Subject: **ACTIVE TRANSPORTATION PROGRAM – PROJECT SCOPE
AMENDMENT – FORT ORD REGIONAL TRAIL AND GREENWAY: CALIFORNIA
AVENUE SEGMENT PROJECT
RESOLUTION ATP-P-2425-13**

PROJECT NAME: Fort Ord Regional Trail and Greenway: California Avenue Segment

This document serves as supplemental information to the Exhibit 25-D REQUEST FOR PROJECT SCOPE CHANGE (attached) completed by Transportation Agency for Monterey County (TAMC) and submitted to Caltrans on 1-30-25.

Date: 10/17/2024
PPNO: 3130A
Federal PROJECT #: 6143(101)
ATP ID #: 0523000102

Title **IMJIN RD PATHWAY FOOTPRINT
SOUTH ALTERNATE 1 PLAN AND
PROFILE**

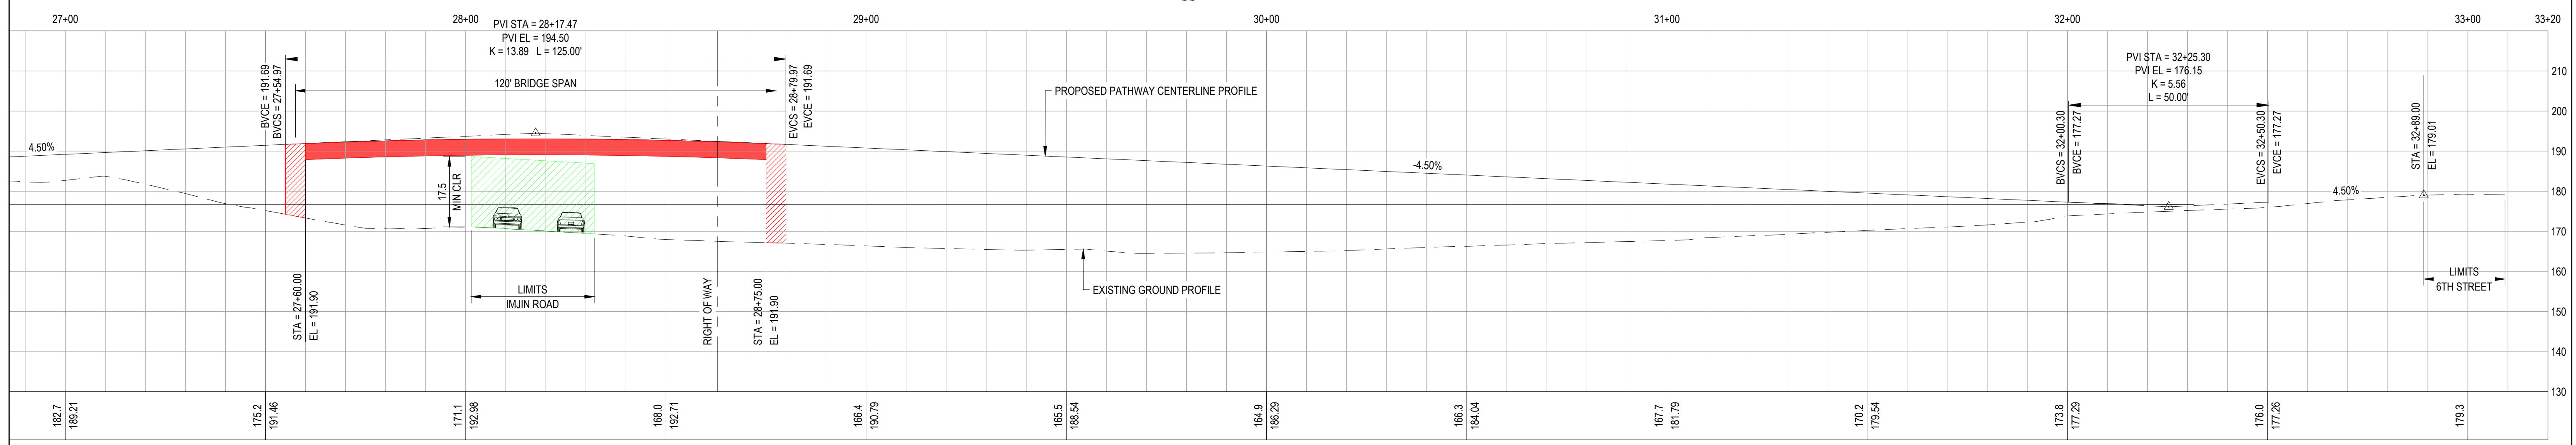
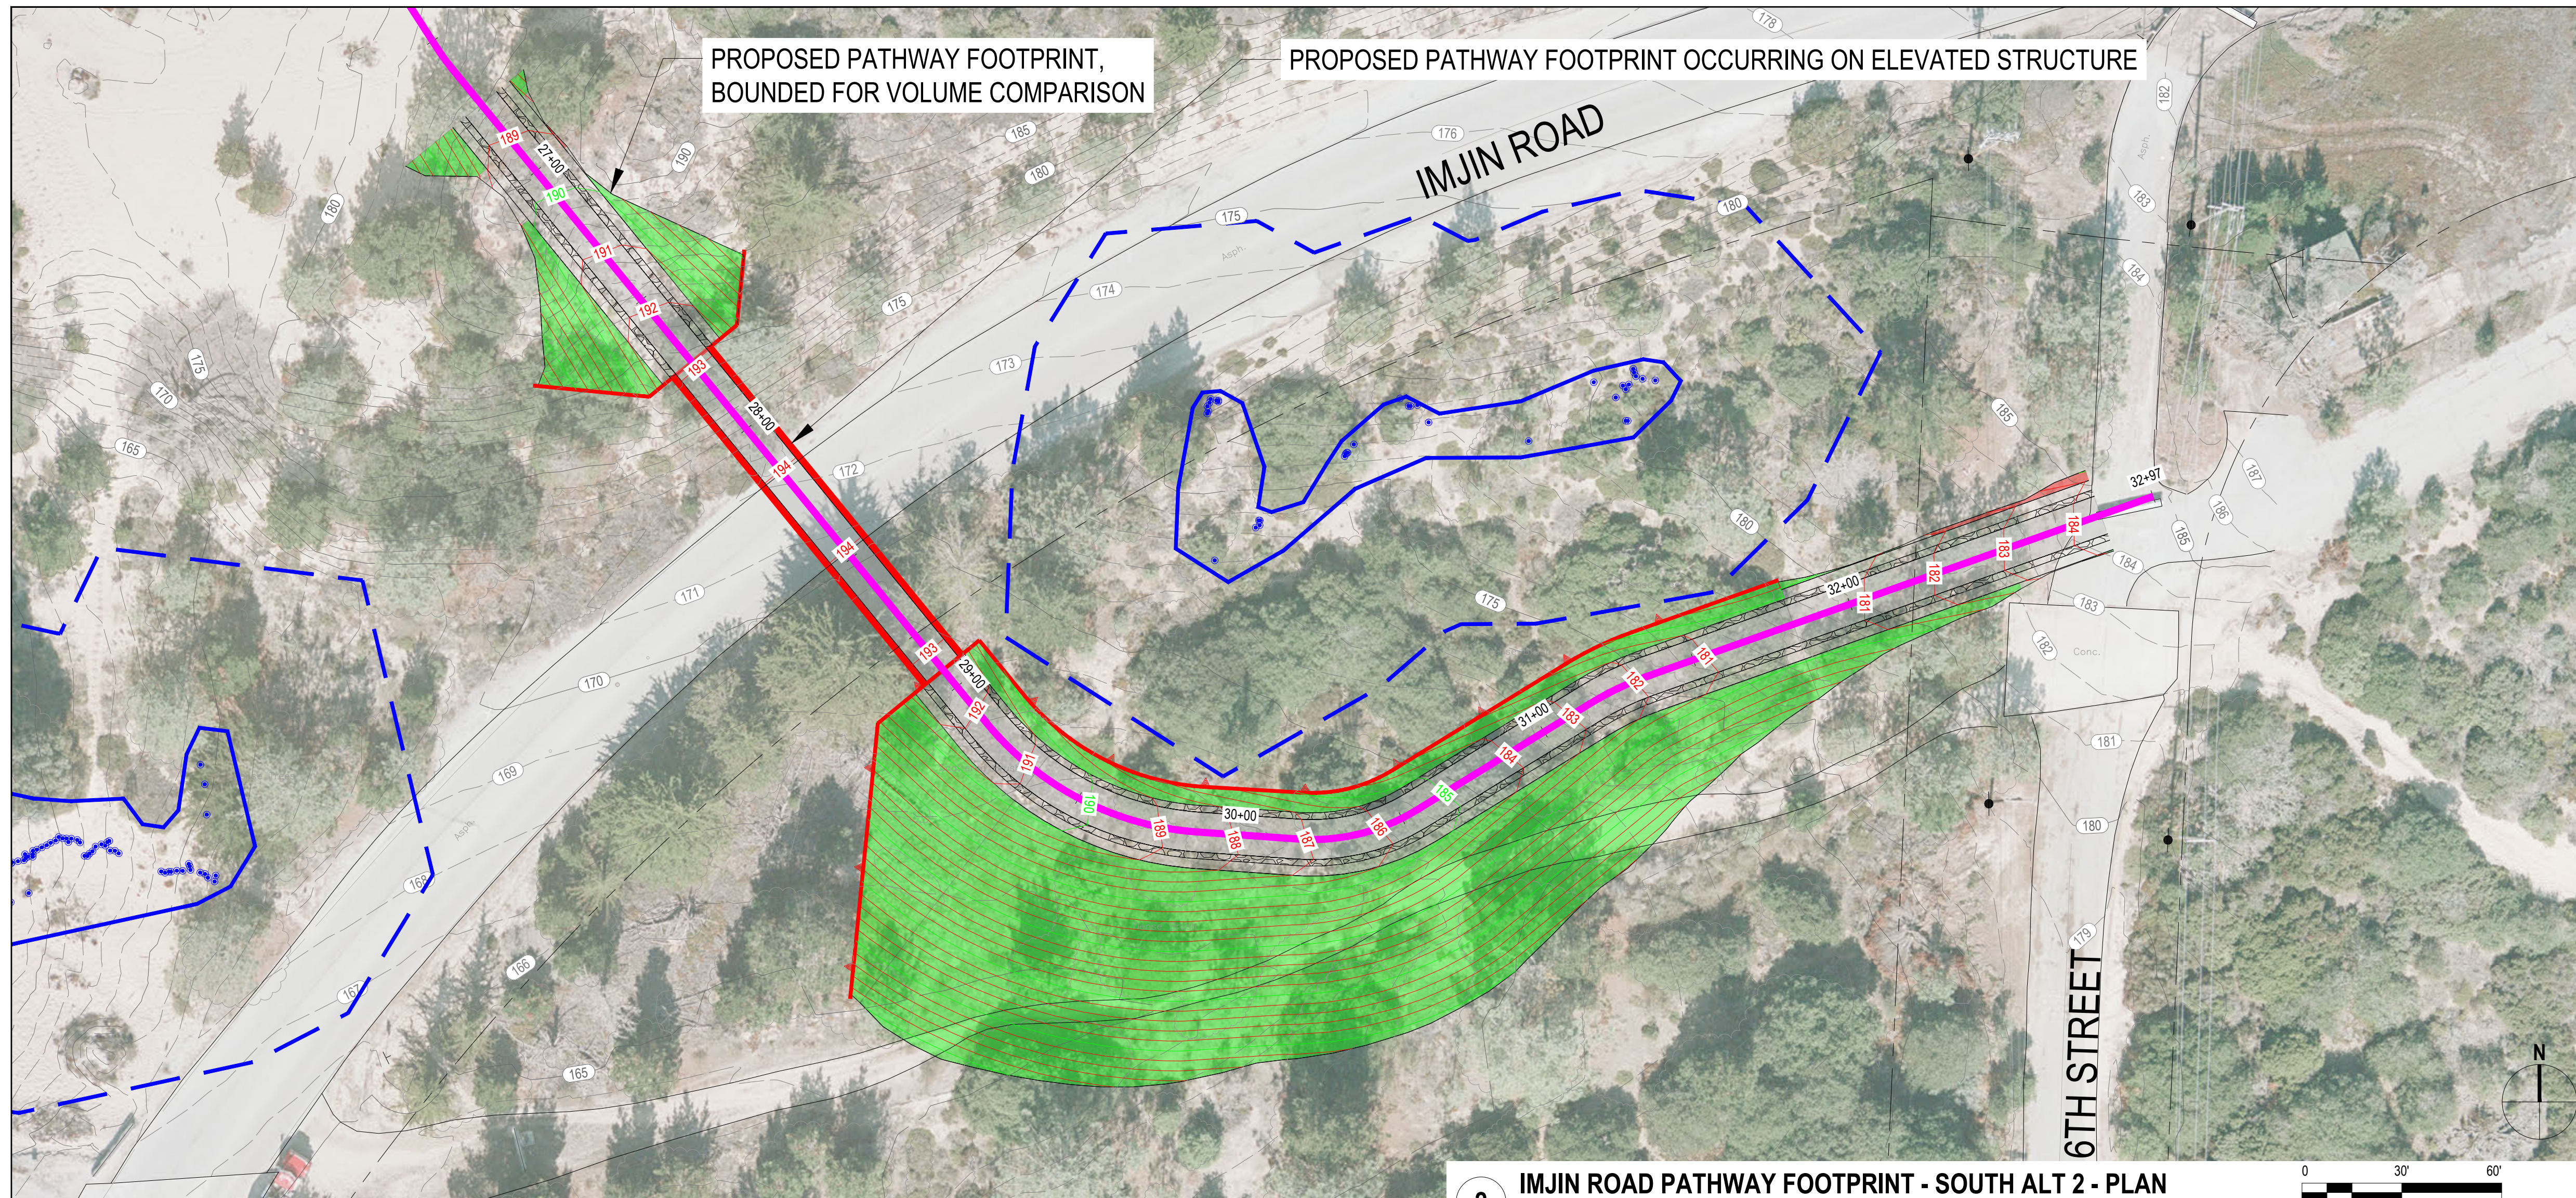
The project team explored four alternative locations for the bridge that would not infringe upon the Gilia’s critical 50-foot buffer zone and took into consideration the topography on either side of the roadway, the clearance requirements for Imjin Road, the sandy soils, and other engineering and environmental constraints. Additionally, geotechnical assessments revealed suboptimal soil conditions that would necessitate extensive and costly foundational support for the bridge abutments, further complicating the original plan.

The four alternatives included preliminary plans and cost estimates that were provided and discussed with the Transportation Agency for Monterey County (TAMC) and the City of Marina. All four alternatives would result in varying degrees of impact to the Gilia and exceeded the original cost estimate for the bridge and mitigation fees. After careful consideration, the decision was made to remove the pedestrian bridge from the project and replace it with an at-grade crossing due to high costs, poor soil conditions, challenging topography and the need to protect sensitive plant species. See Appendix D for bridge alternative plans.
